PRODUCT CHANGE NOTIFICATION

Bourns® SRF1260 and SRF1280 Series Dual-Winding Shielded Power Inductors

Assembly, Process and Gluing Changes

IC25029

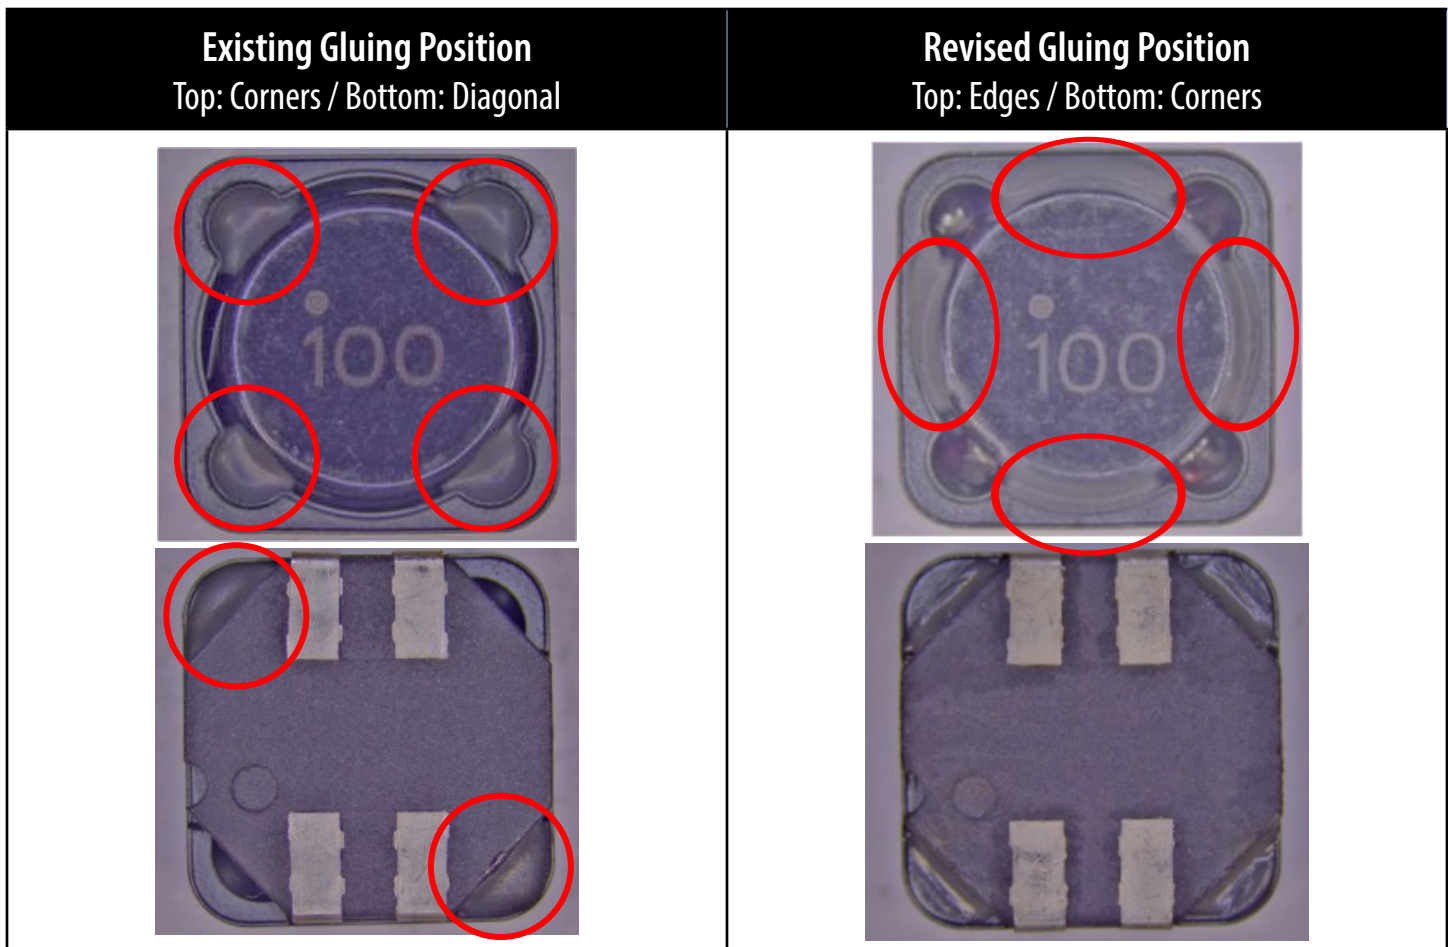
Riverside, California –March 18, 2025 – In the spirit of continuous improvement, effective September 29, 2025, Bourns will change its assembling and gluing processes from manual to automated for the [SRF1260](#) and [SRF1280](#) Series Dual-Winding Shielded Power Inductors. The type of glue and its application position will also be changed to enhance durability. The new glue supplier has been qualified and is included in the Bourns Authorized Vendor List. Additionally, the copper wire color will be changed from gold and red to gold only. A list of affected part numbers is included below.

As shown in the images above, the form of the affected part numbers will change slightly due to the change in gluing position. The fit and function of the affected inductors will remain the same. The quality and reliability of the affected inductors should be improved as a result of the changes. Traceability will be maintained through lot code and date code.
